DIVISION OF DRINKING WATER
Marie E. Owens, P.E.
Director

August 20, 2020

Subject: **Inspection Report**, Johnson Well No. 1 (WS005) Inspection and 160K Tank (ST002) and 250K Gordon Creek No. 1 (ST003) Tank Repair Inspection; Highland Subdivision Water System, System #15005, File #7100

Gordon Creek Chlorinator (TP002) flow meter and dosing point

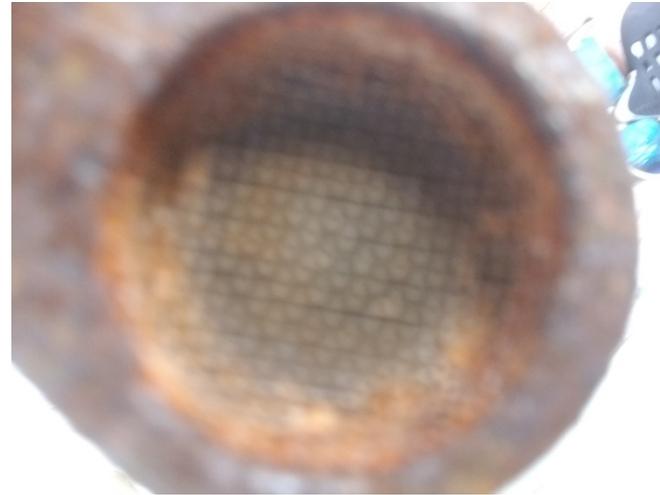
In light of recent water quality sampling the Division will be reviewing the CT calculations for the Gordon Creek Chlorinator, known as TP002 within the Division's database. The Division viewed the Gordon Creek Chlorinator (TP002), seen in the attached photos 16 through 18, located near the Gordon Creek Tanks. The flow meter shown in Photo 17 was identified as the point where DWRi flow data for all the current Highland Subdivision's sources is recorded. This flow meter measures the flow of water treated by the Gordon Creek Chlorinator (TP002) and delivered to the water system's tanks in parallel.
